## HISTORIC AND DESIGN REVIEW COMMISSION

**HDRC CASE NO:** 2021-354  
**ADDRESS:** 607 HEMISFAIR BLVD  
**LEGAL DESCRIPTION:** NCB 13814 BLK 3 LOT 15 (HEMISFAIR SUBD)  
**ZONING:** D, H, RIO-3  
**CITY COUNCIL DIST.:** 1  
**DISTRICT:** Hemisfair Historic District  
**APPLICANT:** Davis Sprinkle/Sprinkle & Co. Architects  
**OWNER:** CITY OF SAN ANTONIO  
**TYPE OF WORK:** Construction of an addition, modifications to the historic structure, installation of an outdoor dining area  
**APPLICATION RECEIVED:** July 16, 2021  
**60-DAY REVIEW:** Not applicable due to City Council Emergency Orders  
**CASE MANAGER:** Edward Hall

**Historic and Design Review Commission**  
***Design Review Committee Report***

## Bombay Bicycle Club at Hemisfair - Project Description

# BOMBAY BICYCLE CLUB - SITE PLAN/ FLOOR PLAN

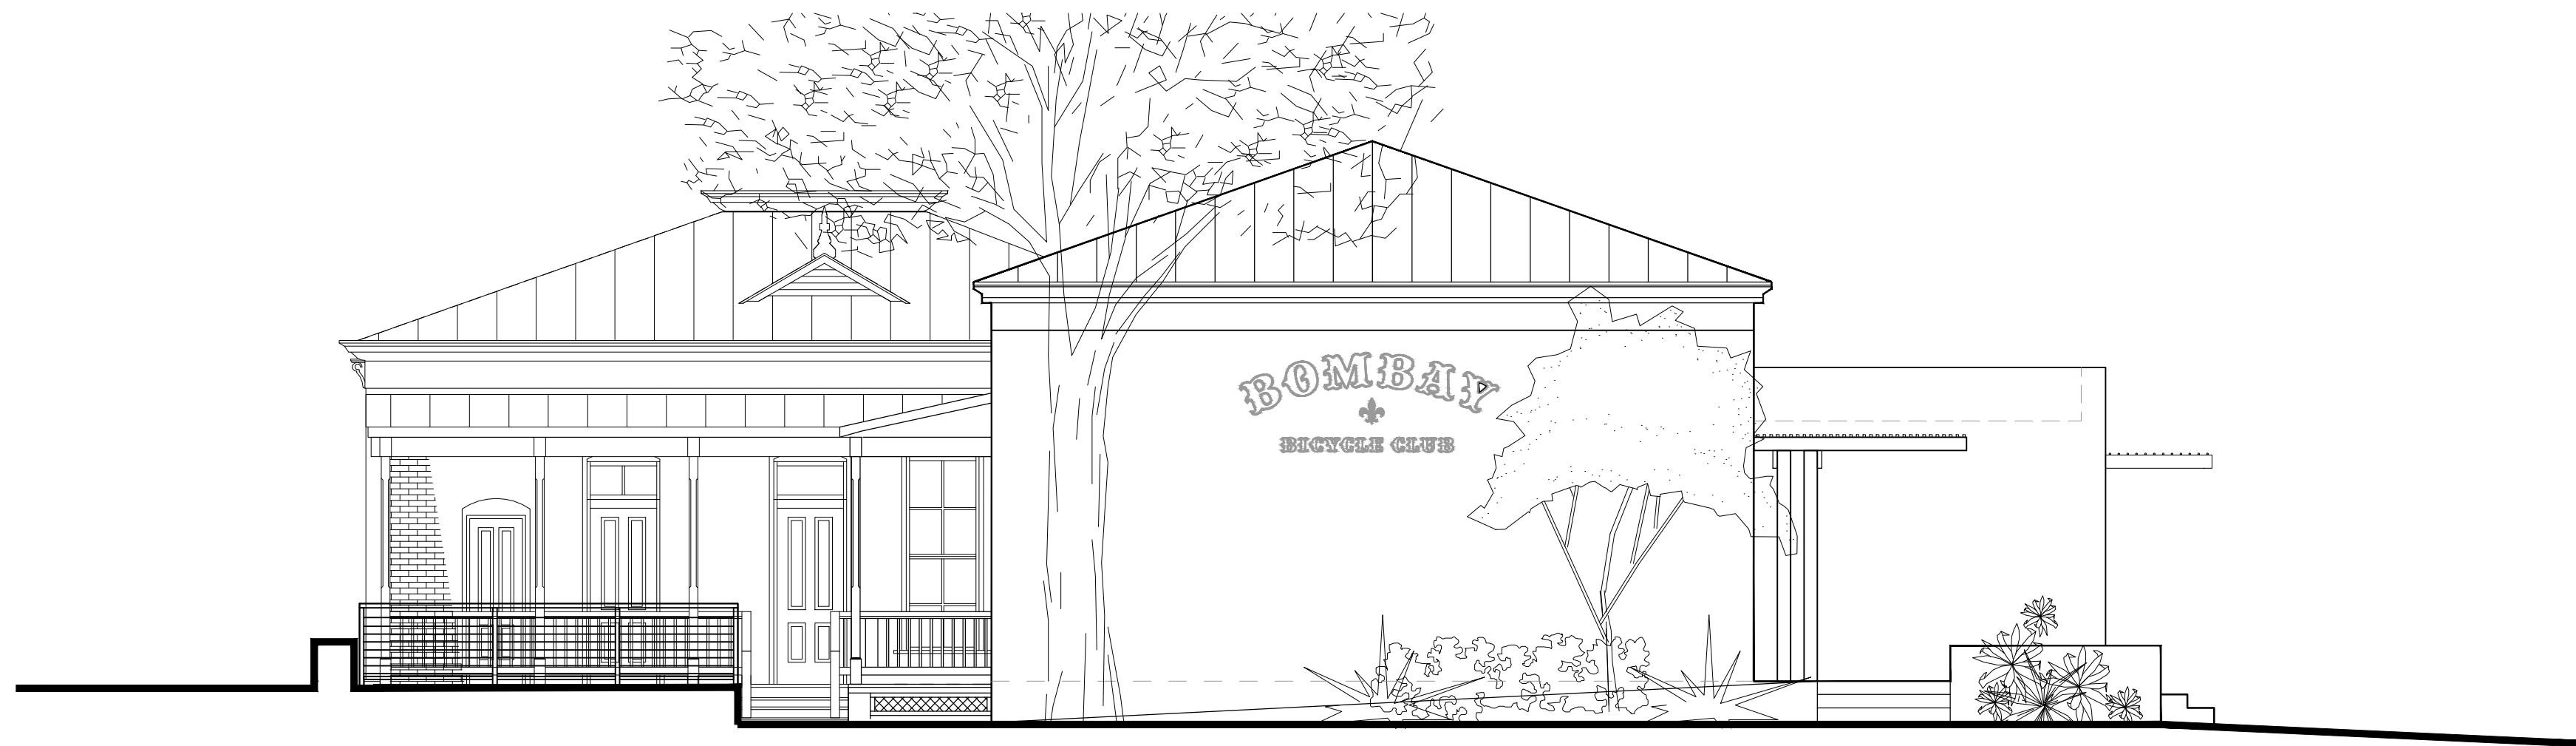
SC: Graphically note the footprint of the original house in relationship to the proposed addition.

DS: North wall would be completely replaced. Plan is to keep the covered porch (dismantled and reconstructed).

JF: Concerns regarding the complete removal of the later addition. Encourages the applicant to reuse or maintain the existing wall of the addition. DS: Possibly could be.

JF: Concerned that the space between the Espinoza House and kitchen might possibly be a location for garbage and deliveries – concerned about that.

SC: Could the setback of the kitchen addition be increased? DS: Possibly.

BOMBAY BICYCLE CLUB - SITE PLAN/ FLOOR PLAN

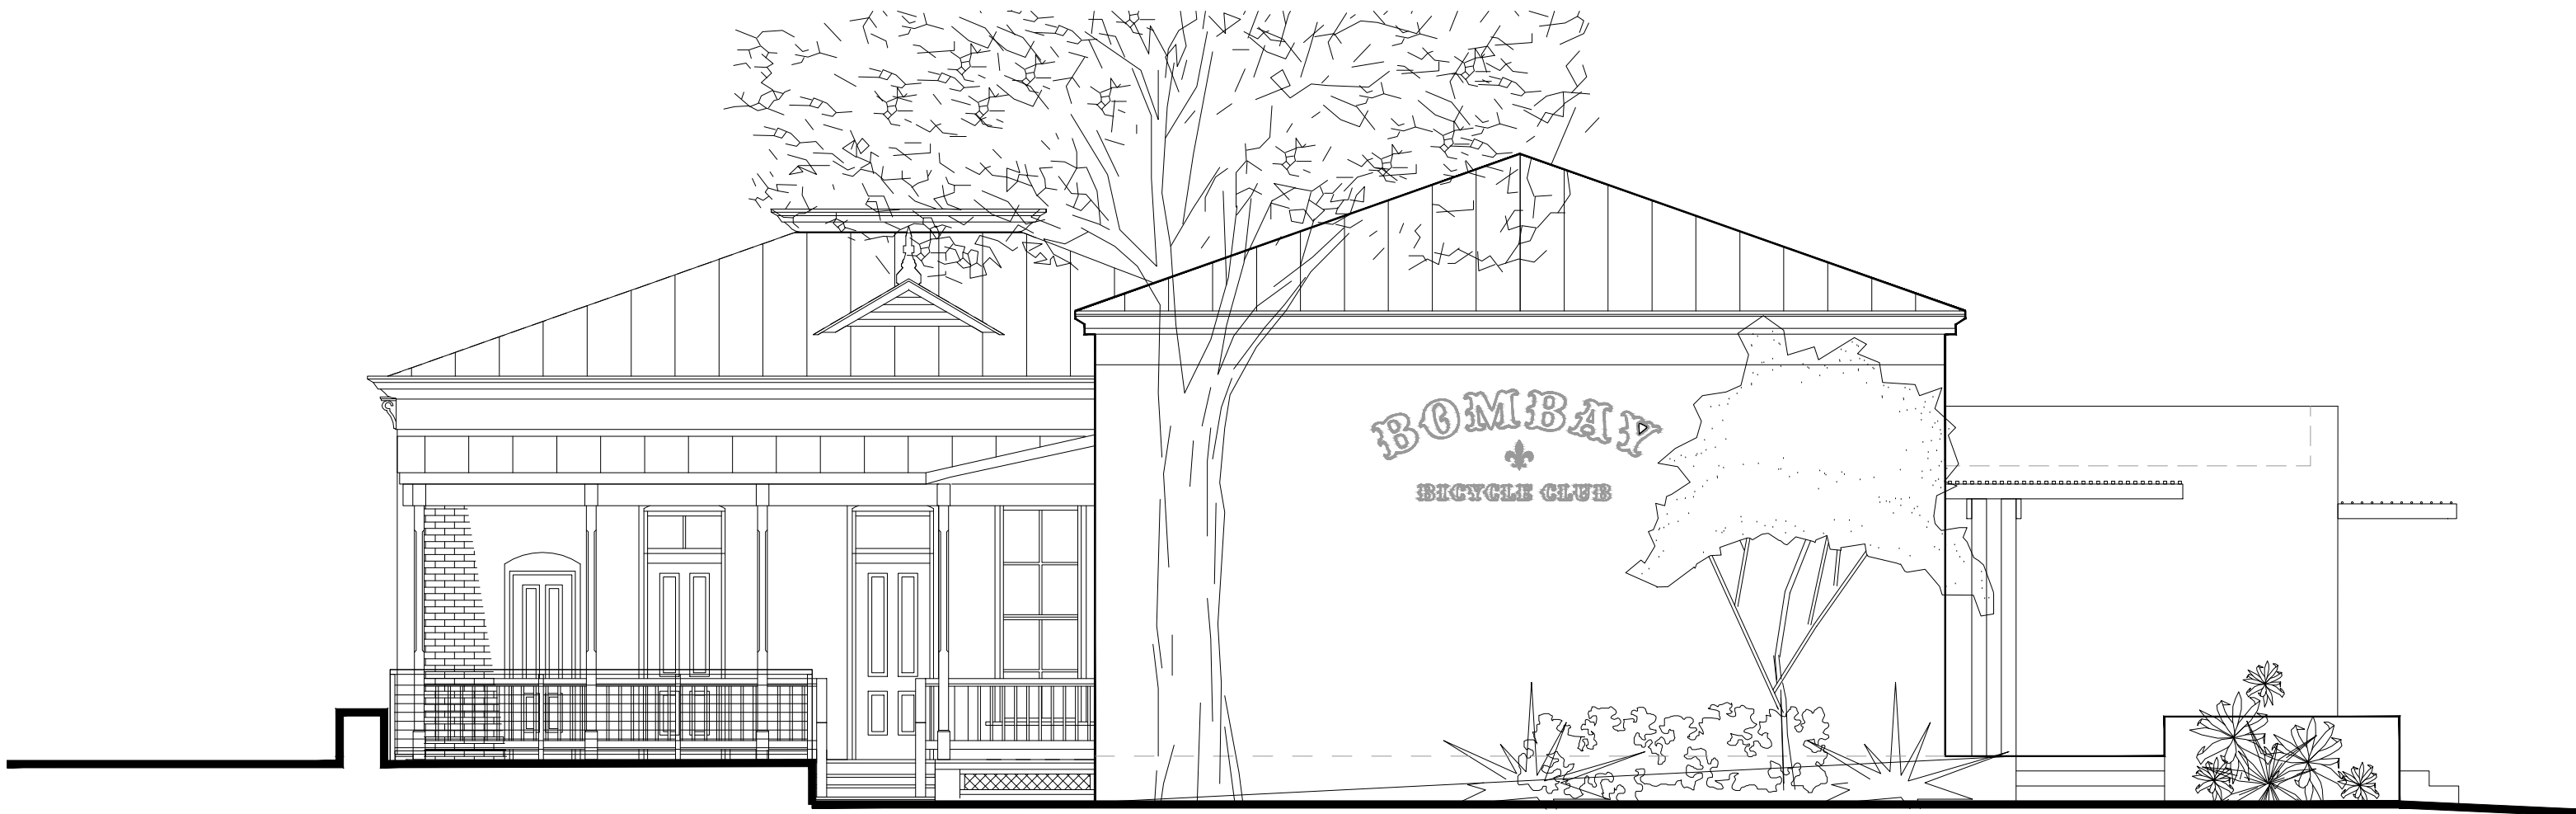
REVISIONS SUBMITTED TO ADDRESS STAFF'S COMMENTS - NOT INCLUDED IN STAFF'S REPORT

Modifications to the exterior of the Espinoza House will occur only at the narrow rear wing of the house. The rear wing will be partially demolished and replaced with a new volume that will contain the main dining room/bar. The existing wood porch attached to the rear wing will be preserved and the exterior wall of the rear wing facing the existing deck will be preserved as well. All of the exterior existing brick walls of the Espinoza House will remain untouched.

The outdoor area at Cesar Chavez and Hemisfair Boulevard will be activated by outdoor dining areas that will have a “beer garden” feel. The addition is pulled away from the side of the Espinoza House that will help the addition defer to the historic portion and minimize impact to the historic structure. The addition is pulled back from the front of the house to defer to the prominence of the historic home. The architecture of the addition will contrast to delineate what is historic and what is contemporary. No trees will be removed for this project.
